Access Compliance Report Public Rights-of-Way (Pedestrian Signals)

Main Street: CROWN_VALLEY_PKWY Cross Street: CROWN_VALLEY_PKWY Location: NW

ADA ID: SGRK211026120429 Signal Type: One Push Button-Non APS Overall Compliance: No Severity Scores: BTN 1: 35 BTN 2: N/A No BTN: N/A

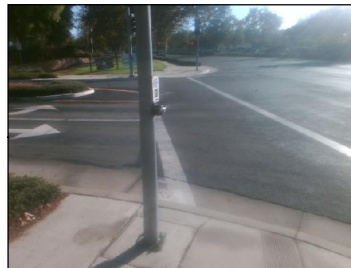
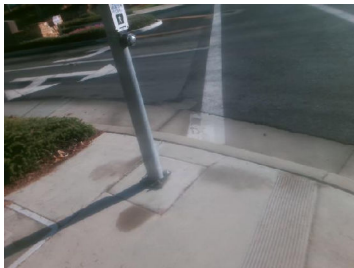
OC Std/PROW: R404.2, MUTCD 4e.08

Possible Solutions: Replace Signal Push Button With APS Button. Remove and Replace Clear Space.
